<b>Title</b>	Noise Documentation Review		
<b>Project</b>	Gatwick Airport DCO		
<b>Reference</b>	28AD.NT.1.1	<b>Author(s)</b>	BHo
<b>Date</b>	13 February 2024	<b>Reviewer</b>	VC

1.1 This note sets out Suono’s initial review of the noise chapter submitted as part of the DCO Environmental Statement (ES), as well as its appendices and specific documents referenced within.

**Figure 1: Proposed and Extant Noise Insulation Schemes**

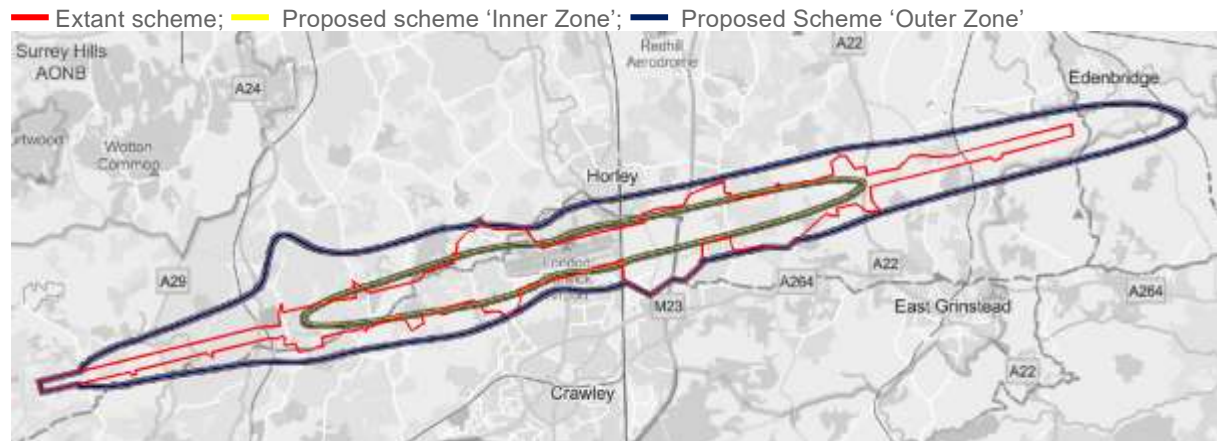
6.1 The proposed scheme would lead to reduced funding and insulation choice being available at a number of locations. Suono have been able to overlap the two figures on Figure 14.8.1, which is shown on Figure 1 below.

6.2 The Outer Scheme is actually divided into three zones itself, each with different funding levels, as set out in section 4.1.11 of Appendix 14.9.10 Noise Insulation Scheme [APP-180]. The lowest level of funding available is £3,500 (54 dB to 57 dB  $L_{Aeq,16hour}$ ), which is less than the £4,300 currently offered as part of the scheme. There is also only a small improvement financially to those within the next zone up to £5,000 (57 dB to 60 dB  $L_{Aeq,16hour}$ ).

6.3 Dwellings in the Outer zone will now only be offered acoustic ventilators, rather than the current offer of glazing, which may constitute another disbenefit depending on the property.

6.4 The figures provided by the Applicant include coloured highlighting around the Zones and the actual extent of the zones is not clear.

6.11 The Applicant should update the scheme to ensure that all residents receive a better offer than currently available, as well as removing the upper funding cap and widening the scheme.
